GOVERNMENT OF THE DISTRICT OF COLUMBIA
DEPARTMENT OF TRANSPORTATION

MEMORANDUM

SUBJECT: ZC Case No. 14-18 – Brookland Manor/Brentwood Village

Figure 2. Proposed Roadway Network (Source: Applicant)

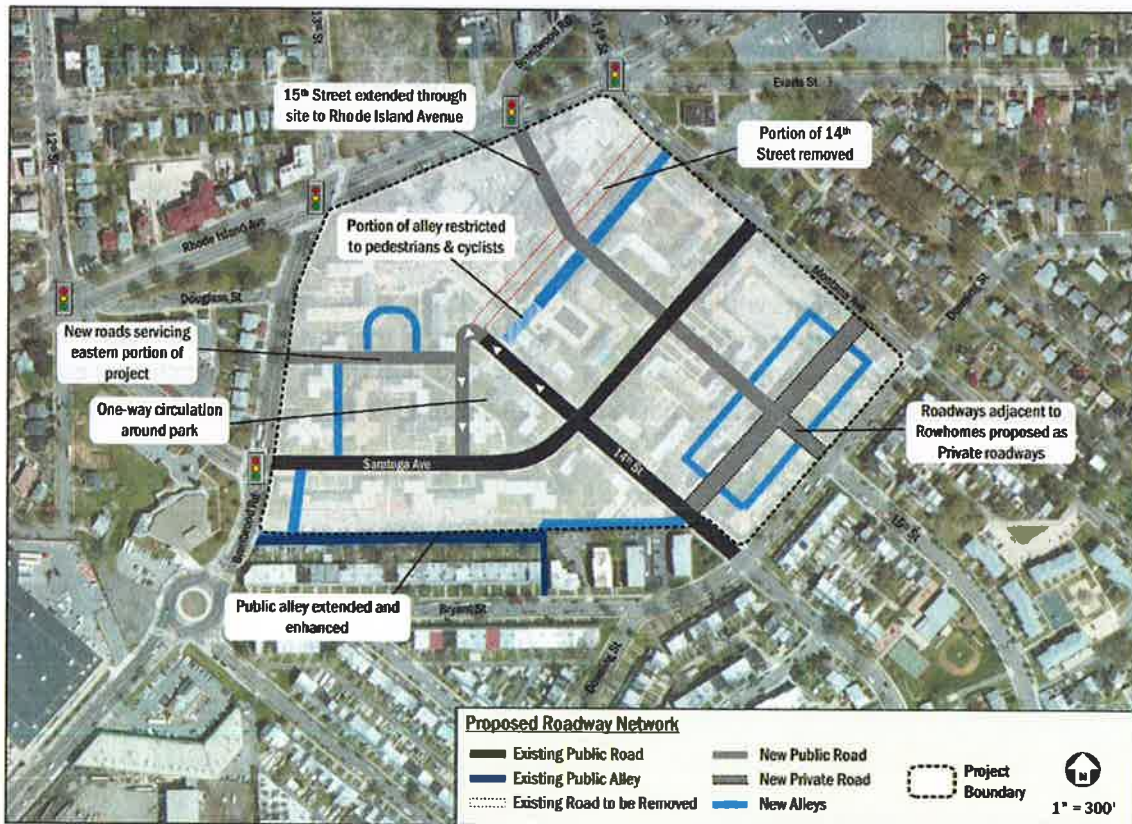
The new street network has the potential to disperse Site traffic throughout the Site in a way that minimizes the action's impact on the road network in the vicinity. The new roads will serve as vehicle, bicycle, and pedestrian access points for the Site.

Figure 4. Pedestrian Pathways (Source: Applicant)

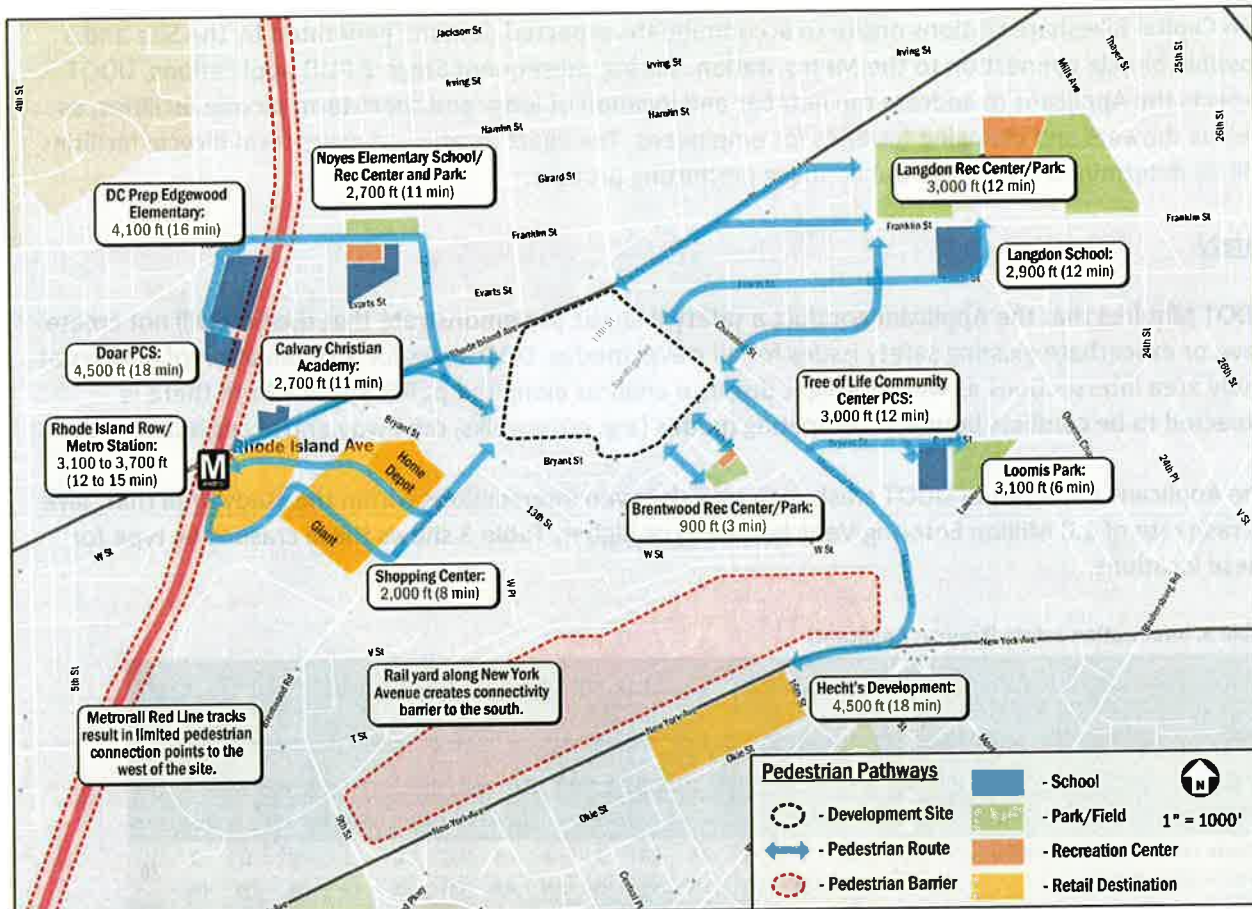
As discussed in the Site Access section, the Applicant is expected to work with DDOT through the public space permitting process and/or street dedication process to ensure that pedestrian access points provide safe and convenient Site access, with a focus on connecting to adjacent neighborhoods and connections to major trip production or attraction areas such as the Metro station. DDOT expects the Applicant to meet all DDOT standards for pedestrian facilities.

In this area, the key destinations are the Metrorail station as well as the local elementary school. DDOT expects the Applicant improve the pedestrian infrastructure along these routes to DDOT standards.
